AS1428.1-2009 SUPPLEMENT

John Deshon AM
1 May 2011

SUPPLEMENT TO AS1428.1-2009
JOHN DESHON AM 1 MAY 2011

New subclause 15.2.9(e)

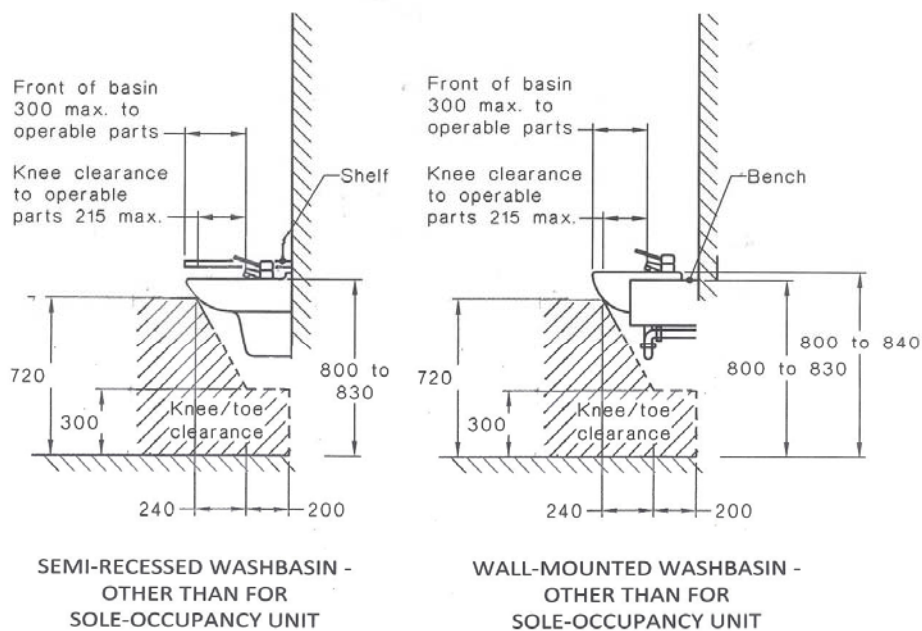
Figure 40(a)

Delete vertical dimensions indicating range for zone of backrest

Add note after "Zone for backrest"

See Figure 39

The dimensions do not meet those shown on the referenced Figure.

RELATIONSHIP OF KNEE/TOE CLEARANCE TO FRONT OF BASIN AND OPERABLE PARTS

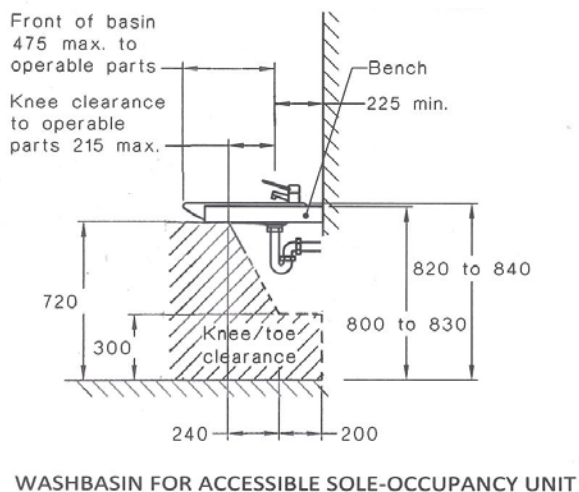
Figures 44(A), 44(B) and 45

Delete Elevation B in all three figures and insert the following:

Amendment No 1 deleted an essential dimension, namely the relationship between the top of the knee/toe clearance and the operable parts. Without that, there is nothing to establish a minimum basin front-to-back dimension.

A basin of, say, 200mm overall depth meets the Standard but is not accessible.

The opportunity is also taken to separate the wall alignment from the toe space.

The consolidated version neglected to include the Amendment No 1 definition of "operable parts" at Figure 45 and left out "water source" as an operable part altogether

Note 1: "Operable parts" means the water source and the centre-line of the tap, or where a lever handle is provided, the end point of the lever measured throughout its arc of movement, or where a sensor is provided where the sensor is reliably activated.

Note 2: The knee/toe clearance is the minimum clear space required. Its location is related to the operable parts and the front of the basin, not the wall at the back of the basin.
